Inspection Report for North Sturbridge Road Solar Facility

NPDES ID No.: MAR10031G

Inspection Date: 11/15/2021

**FIGURE 1:
 SWPPP
 INSPECTION
 SKETCH
 11/15/2021**

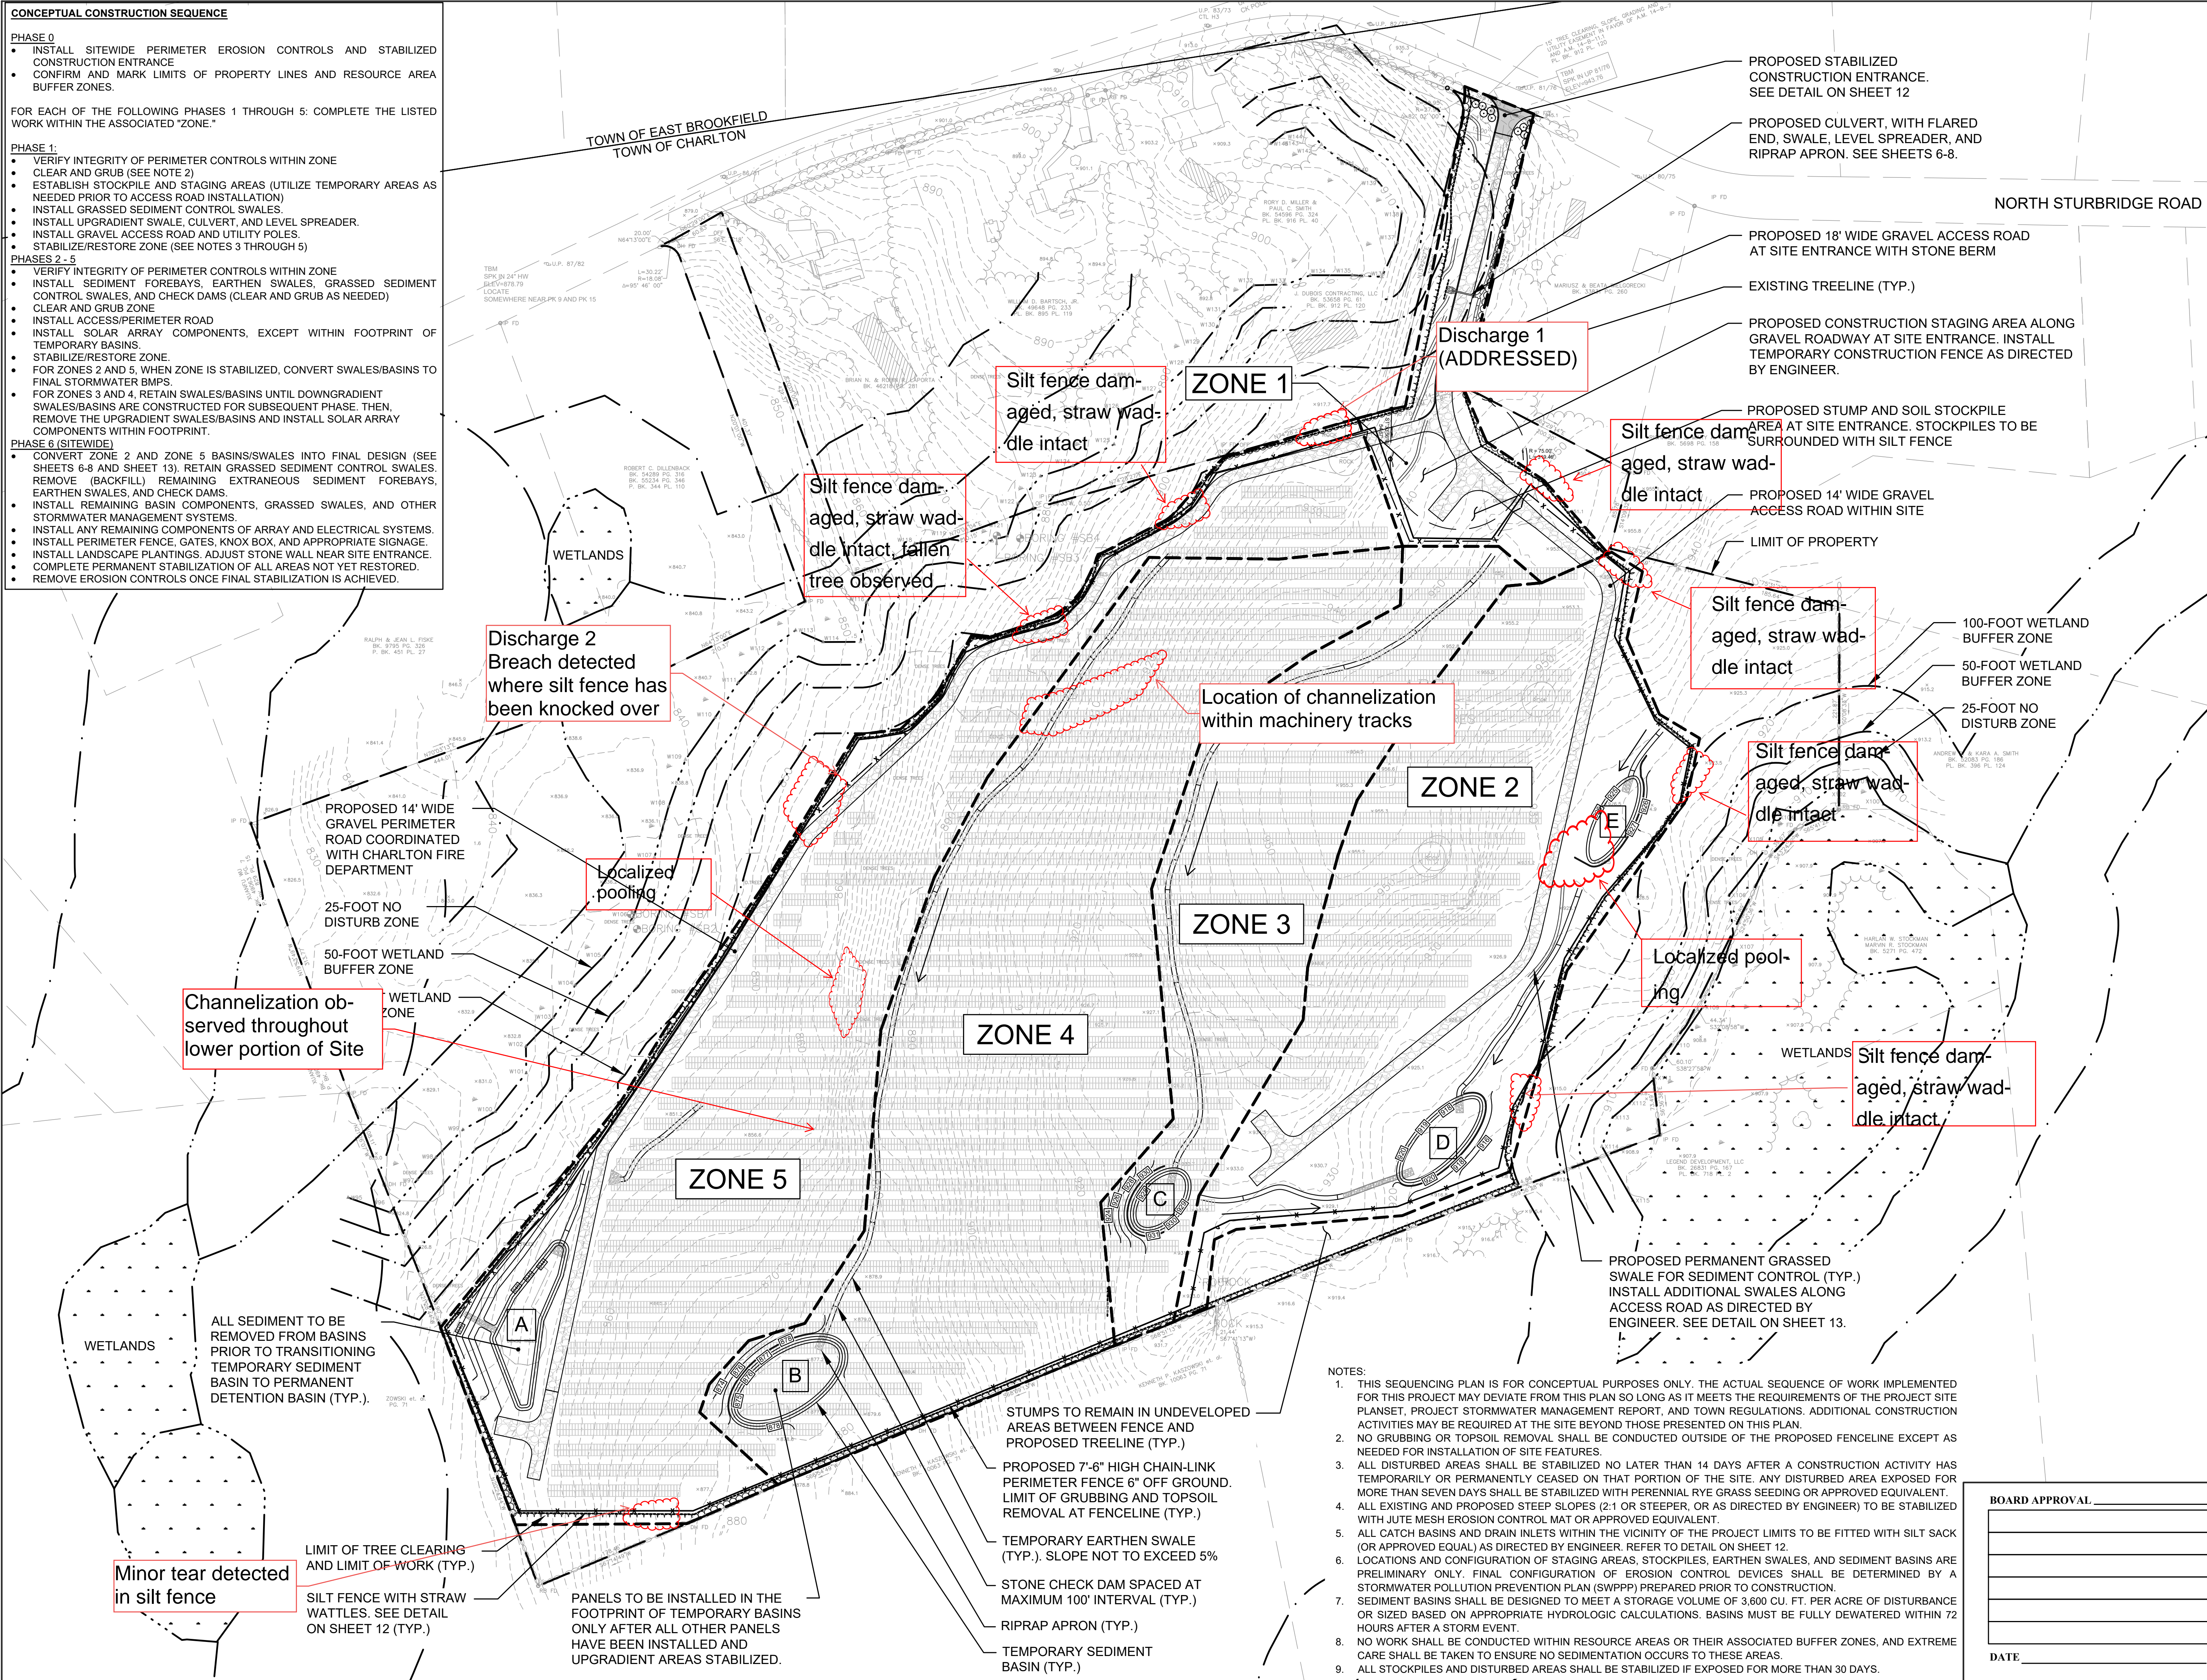
2. Informal access road along northern portion of the Site	Straw mulch or hydroseed	<input type="checkbox"/> Yes [Enter date] <input checked="" type="checkbox"/> No	Erosion channels are beginning to form within upgradient portions of the informal access road (Figure 1). The contractor indicated that stabilization by smoothing out soils and seeding or spreading mulch would occur on 7/30/2021. Stabilization of this area has not been initiated. After inspection of the area on 8/24/2021, it was determined that

Channelization observed throughout lower portion of Site
